Follow-up Urgent Field Safety Notice

ACHC25-07.B.OUS

Title	Potential for Falsely Depressed Results with the Atellica CH UCFP Assay
Date Issued	Aug-2025

Appendix Customer Actions – Enable QC on Pack Change By Assay Type

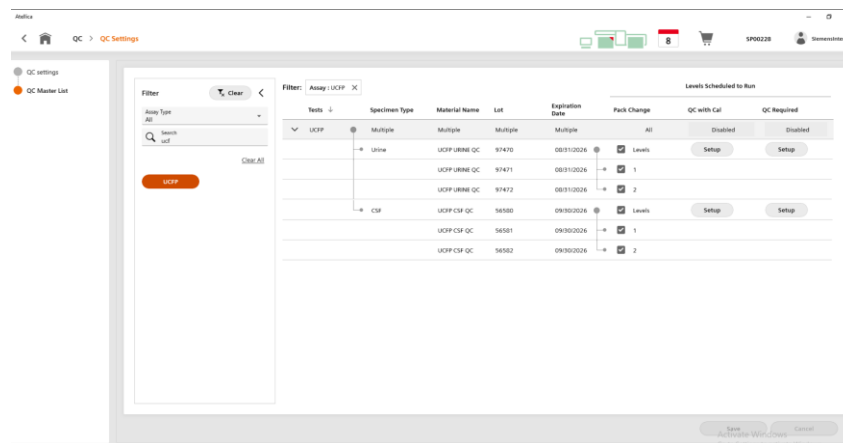
1. From the System Navigator icon under QC, select **QC Settings**.
2. Under QC Mode Settings, select **By Assay Type**.

3. For CH, click the drop-down menu for **QC on Pack Change** and choose **Enable**.
4. Select **Save**.
5. Under QC settings, click on **QC Master List** and search for UCFP.
6. If pack change is not set to All, click **Setup** and select all QC levels for both sample types.
7. For all CH assays for which QC on Pack Change is not required, expand the QC list and deselect all levels of QC.

8. Select **Save**.
